March 21, 1996

Subject: Byron Station Units 1 and 2
Braidwood Station Units 1 and 2
Supplemental Response to the NRC Request for Additional
Information Regarding Ampacity Derating Analyses
NRC Docket Numbers 50-454/455; 50-456/457

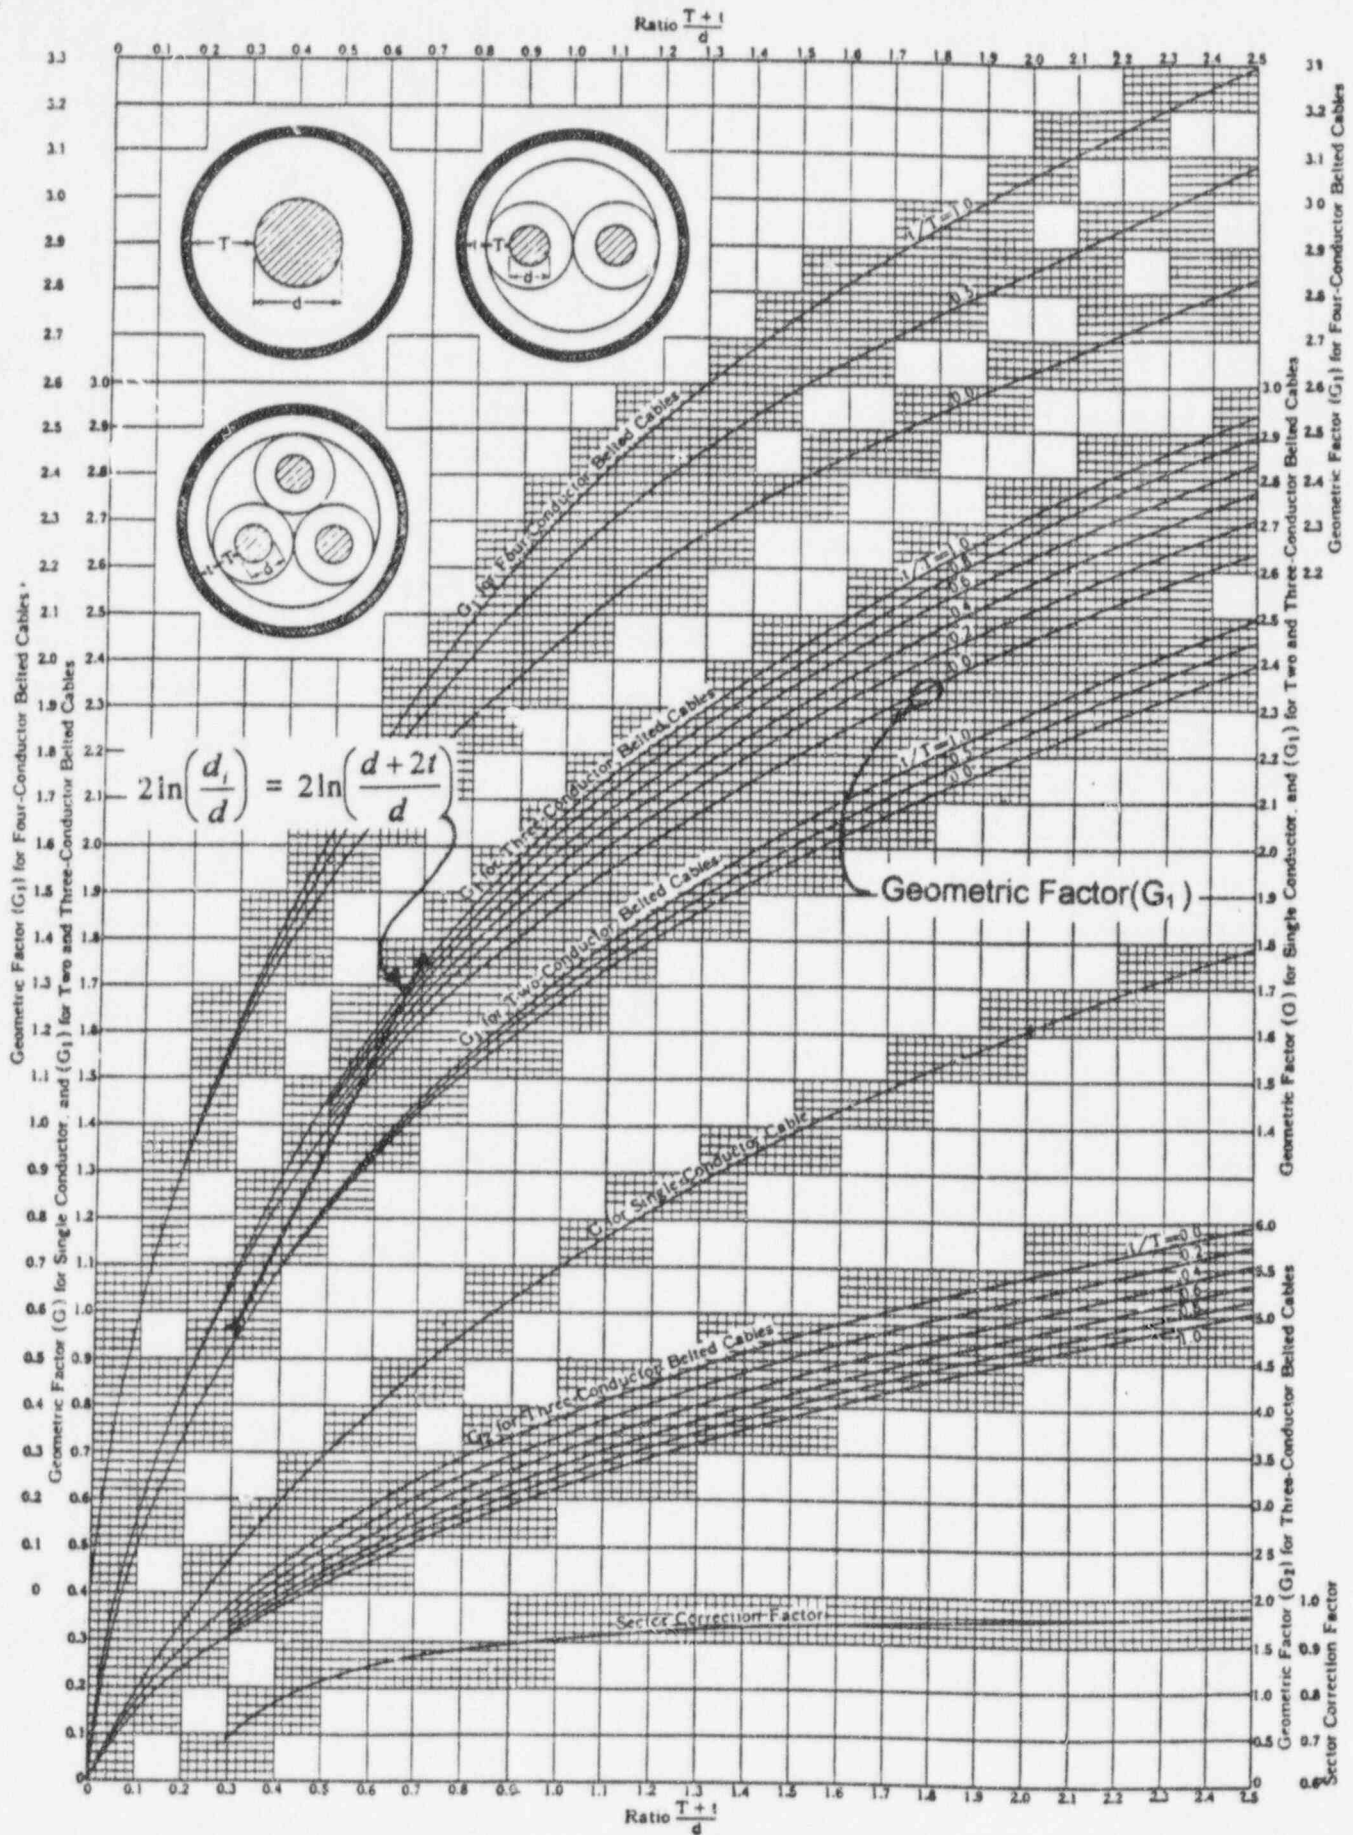
- 4) **Observation/Question(Ref.: Item 4, Page 5):** *"Given the information provided, the nature of the cable insulation and jacket resistance calculations are not clear. Specifically, the calculations presented as the top six lines of page 130 of Calculation G-63 require clarification. Although the calculations attempt to account for the cable insulation and jacket regions as annular regions, why are the multipliers of 2 and 3 applied to various parts of the resistance? How does the licensee justify simply adding the various components without consideration of parallel path heat transfer and the fact that heat is not flowing from the center of each conductor radially through each individual conductor, but rather non-uniformly through the multi-conductor cable as a whole?"*

Answer: The first expression calculates the temperature drop between the conductor and the insulation and individual jacket surrounding each conductor:

where, G is a geometric factor that takes the non-uniform heat flow into account. The expression $2 \ln\left(\frac{d_i}{d}\right)$ closely approximates the values of G, as can be seen in the plot of G taken from *Figure 2, page 13 of the D. M. Simmons paper²*.
